PCR #004
City of Puyallup
E-20-0612

PLAN CHANGE REQUEST 4

1. PROJECT: Ferrucci Junior High School Addition ADDRESS: 3213 Wildwood Park Drive
2. OWNER: Puyallup School District EMAIL: vandelj@puyallup.k12.wa.us
3. DESIGN ENGINEER: Sitts & Hill Engineers, Inc. EMAIL: rickh@sittshill.com

REVISION
EXISTING STORM REPLACEMENT

C3.03A

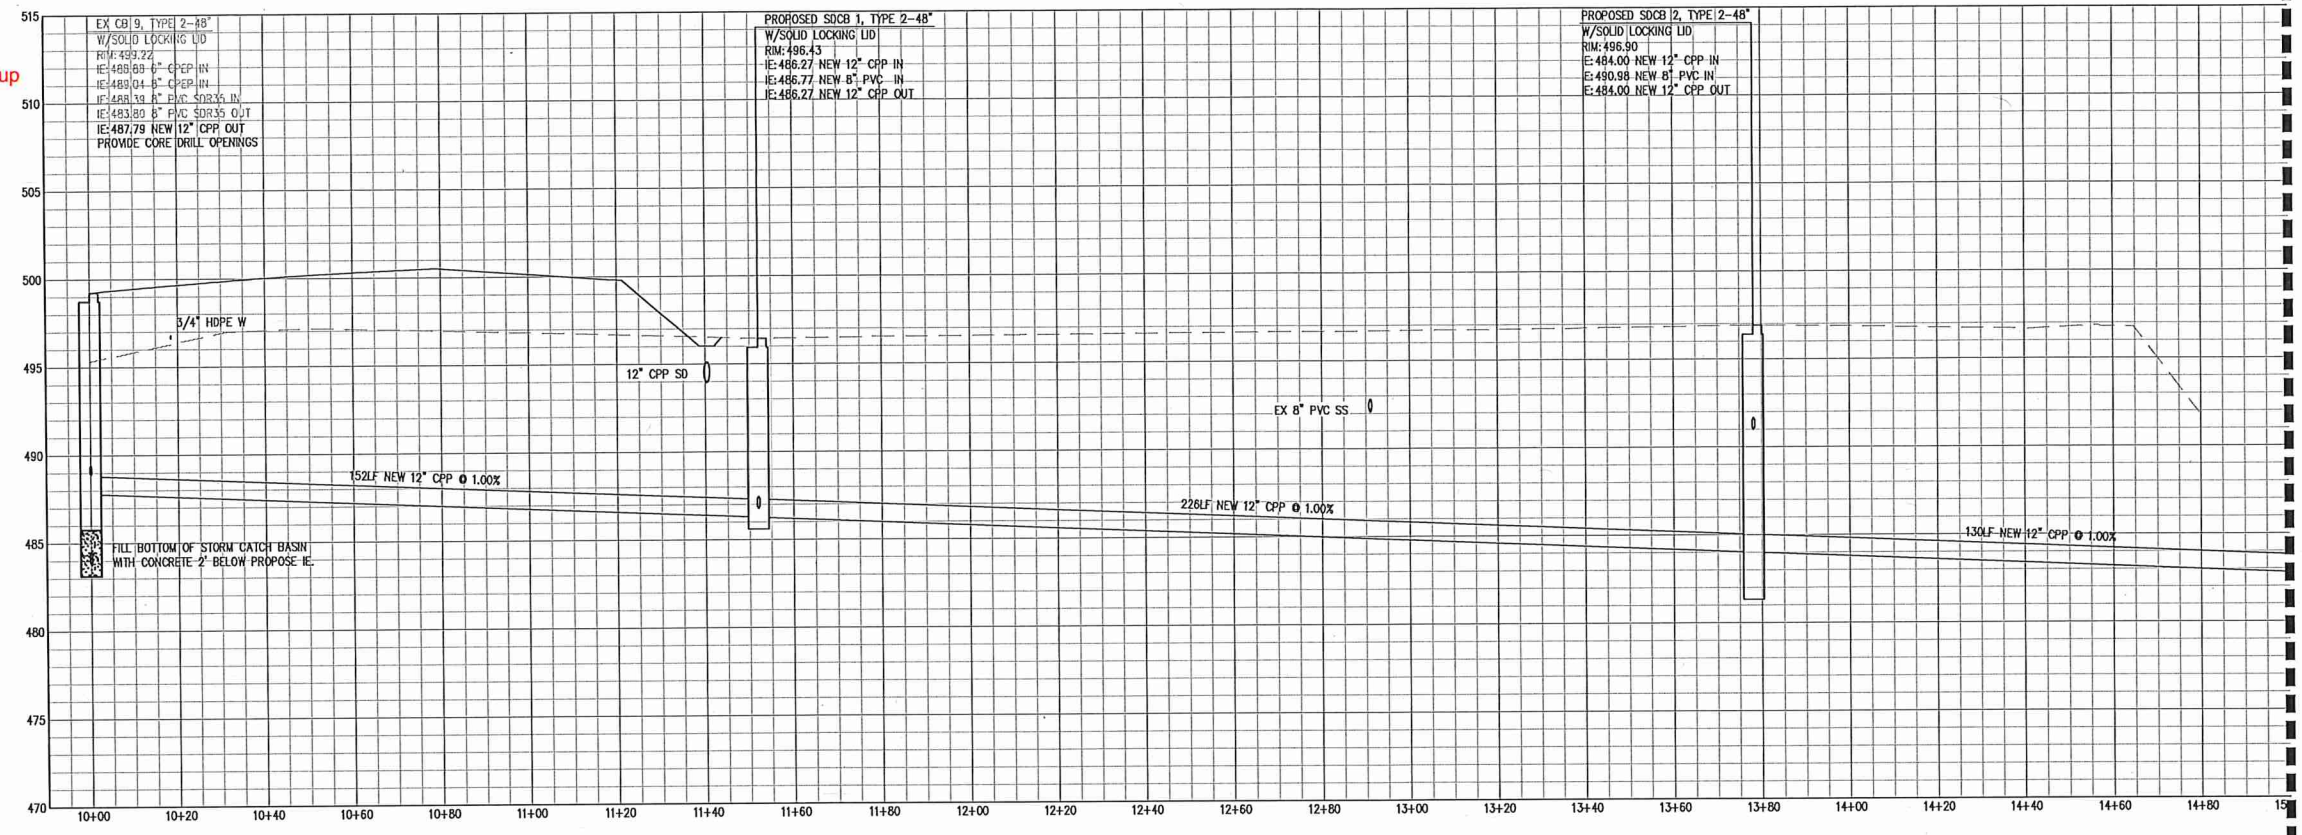
10. WHAT PART OF THE CITY AND/OR DEVELOPMENT INFRASTRUCTURE IS BEING AFFECTED?
☐ ROAD ☒ STORM ☐ WATER ☐ SANITARY ☐ GRADING ☐ EROSION CONTROL
11. DESCRIBE THE CHANGE BEING REQUESTED: (ATTACH ADDITIONAL INFORMATION AS NECESSARY)
During construction, we found the existing site storm drain system to perform poorly. Subsequent TV videoing has revealed that there are a couple of plugs in the existing storm system that have been or are being addressed. Also, numerous existing pipes have debris in them, showing corrosion, or have standing water in them. The design engineer's assessment is that these existing CMP pipes are at or near failure and we recommend replacement with CPP and PVC pipes. NO additional conveyance is being added—just a remove and replace. This is essentially a maintenance project. Therefore, NO conveyance or stormwater site plan report is required.

7.2.1. Pothole and verify existing SD elevation at SDMH 1 and report information the Engineer.

2. Wait for 2 days of drier weather forecasted. Install the 146 LF of pipe between the existing control structure SDMH 14 and SDMH 1. Install temp plug in the easterly pipe of SDCB6 or westerly pipe into SDMH 14. If there is trench dewatering during the installation or rainfall, then let it fill the existing pond. If the pond gets too full, then pump between the pond and SDMH 1.

3. Activate the pipeline between the EX Control structure and SDMH 1. Drain the pond.
4. Install 12" mainline located about 60' south of SDCB2 to SDCB2 to SDCB1 to about 20' SE of EX SDCB 9.
5. Install SDCB 6 and the 50'± of 12" pipe north of SDCB 6 and the 47' of 12" pipe east to the Existing Control Structure in 1 dry day.
6. Install the remaining 20LF± 12" pipe to EXSDCB 9.
7. Install pipes and structures west of SDCB 2 and make connections.
8. Install pipes and structures west of SDCB 1 and make connections.
9. If trench dewatering is required for items 4-8, pump out onto fields.

C3.03B

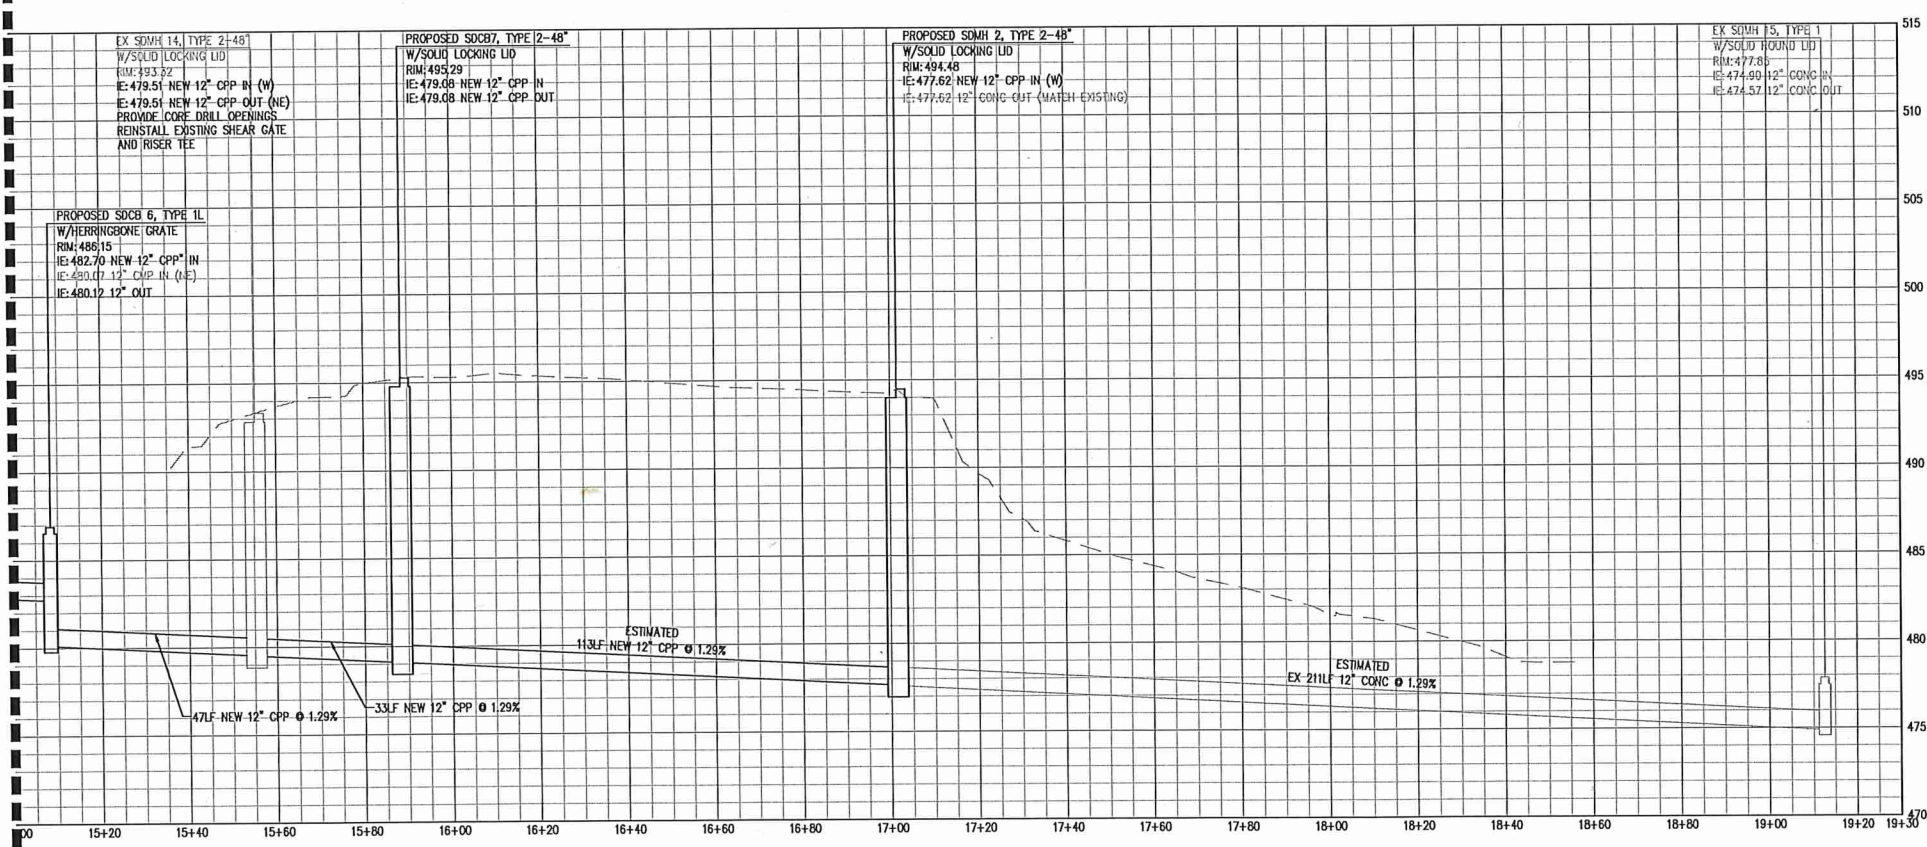
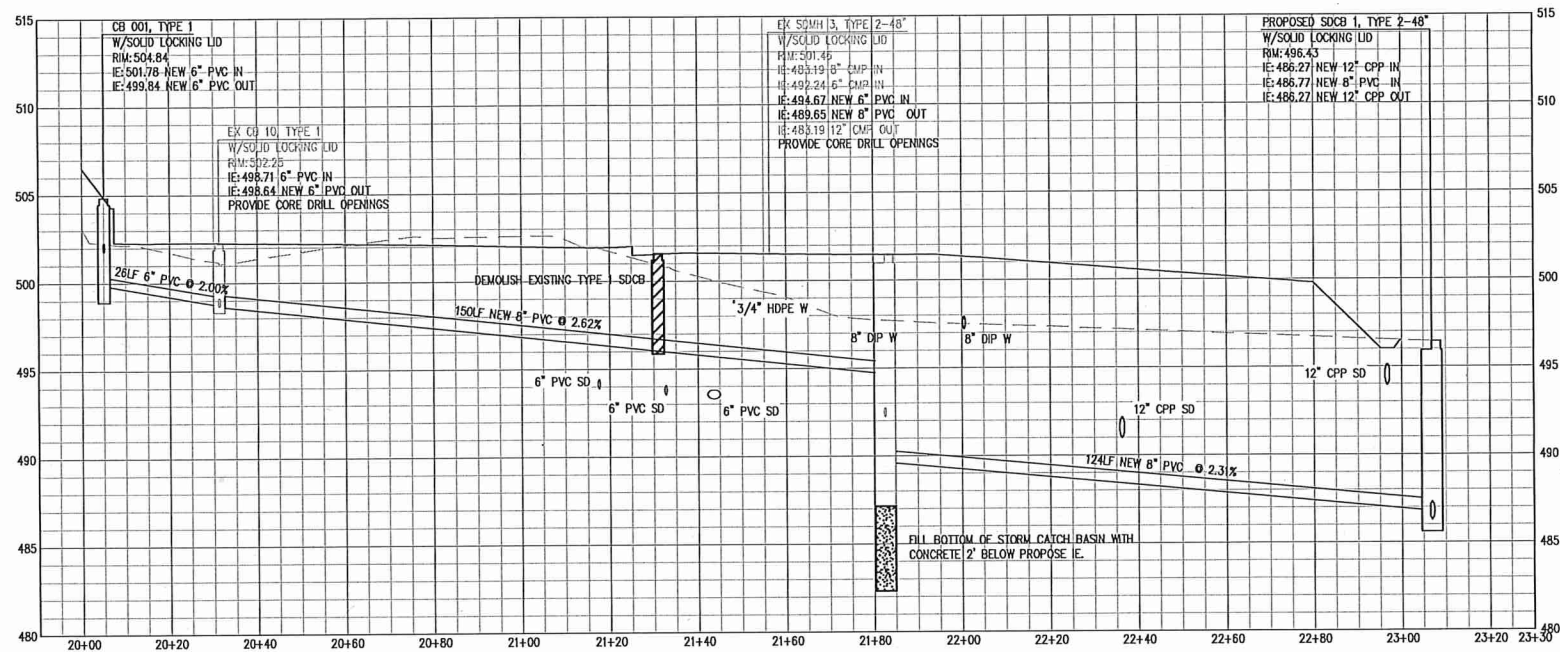
EAST STORM REPLACEMENT PROFILE 1
SCALE: H:1"=20' V:1"=5'
